## Product Change Notification / JAON-04DXFD964

CCB 4541 Final Notice: Qualification of a new lead frame design for selected products available in 8L SOIC package using 8390A die attach and gold (Au) bond wire material assembled at MMT assembly site.

## Pre and Post Change Summary

### PCN # JAON-04DXFD964

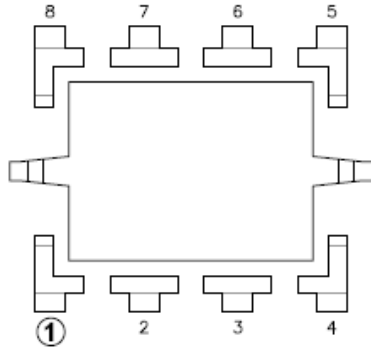
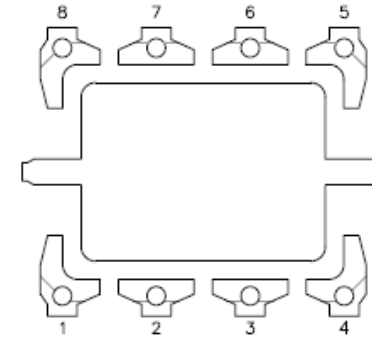
LF STRIP DENSITY: x140  
LF PAD SIZE: 95x130 mils  
LEAD LOCK: NO

LF STRIP DENSITY: x320  
LF PAD SIZE: 95x130 mils  
LEAD LOCK: YES

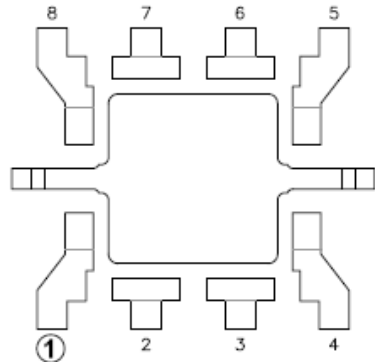
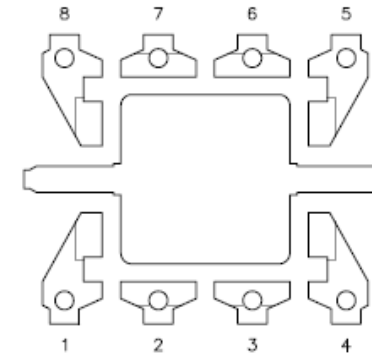
LF STRIP DENSITY: x140  
LF PAD SIZE: 90x90 mils  
LEAD LOCK: NO

LF STRIP DENSITY: x320  
LF PAD SIZE: 90x90 mils  
LEAD LOCK: YES
